PLANNING REPORT

Architectural Review Board

37 W. BRIDGE STREET – SIGN 24-072MPR

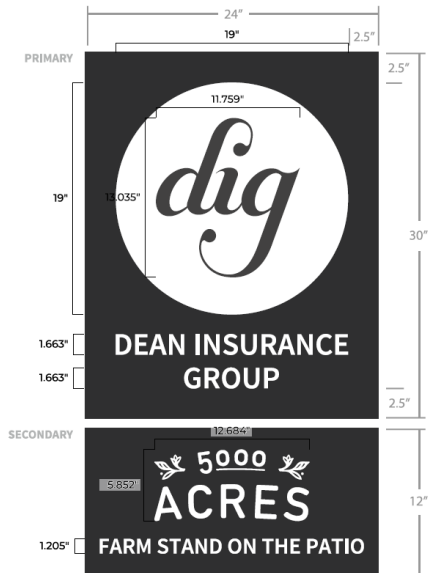
Table 153.173L provides requirements for building-mounted projecting signs, noting that projecting signs must have 8 feet of clearance below when above a sidewalk. Because the proposed sign is projecting over a landscape bed which is clearly delineated from the public sidewalk, Staff has no concern related to the sign having 5.5 feet of clearance at the bottom of the sign.

5. The proposed development is consistent with the <i>Historic Design Guidelines</i> .	Criteria Met with Condition. The proposal responds to the <i>Historic Design Guidelines</i> by utilizing a sign design that meets material and stylistic recommendations. Staff recommends that the bracket be mounted at the mortar joints, rather than into the historic stone. This is in accordance with the Guidelines 7.10 B that projecting sign brackets be "architecturally appropriate", which relates to preservation of historic fabric.

- 1) That the applicant mount the sign bracket in the closest mortar joints, relative to this approved location, rather than drilling directly into the east stone façade in order to preserve the historic fabric of the building.
